Title: Source VCONN Discharge Applied to: USB Type-C Specification Release 1.2

Brief description of the functional changes:

(b). Section 4.5.2.1 Connection State Diagrams, Figure 4-12, Page 134

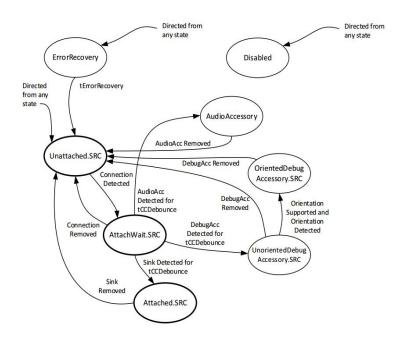
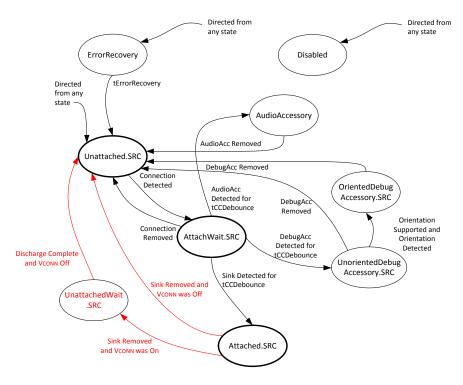
- 1) Add a new state, UnattachedWait.SRC, to the Source Connection State Diagram. No change is required to any other host/device state diagrams. A Source that was providing VCONN in the previous Attached.SRC state will transition from Attached.SRC to UnattachedWait.SRC. A source that was not providing VCONN shall transition to Unattached.SRC. In UnattachedWait.SRC, the source will complete the VCONN turn off and discharge the CC pin that was providing VCONN in the previous Attached.SRC state. The Source exits UnattachedWait.SRC when both the CC pin being discharged is below vVCONNDischarge and VCONN is turned off.
- 2) Modify VCONN Source Bulk Capacitance requirement to be similar to how the VBUS bypass capacitance is specified in USB 2.0 and 3.1.
- 3) Remove degenerate condition, under Table 4-4, for not supplying VCONN.

- 3) This ECR will require the Source to turn off VCONN and discharge the CC pin, that was providing VCONN in the previous Attached.SCR state, to allow the cable to reset Ra to full strength before the Source identifies the electrical state of its CC pins.

- 4) To maintain operability with a connected port that uses Try.SRC Support, the Source in UnattachedWait.SRC must maintain a valid Rp connection on the CC pin connected through the cable.
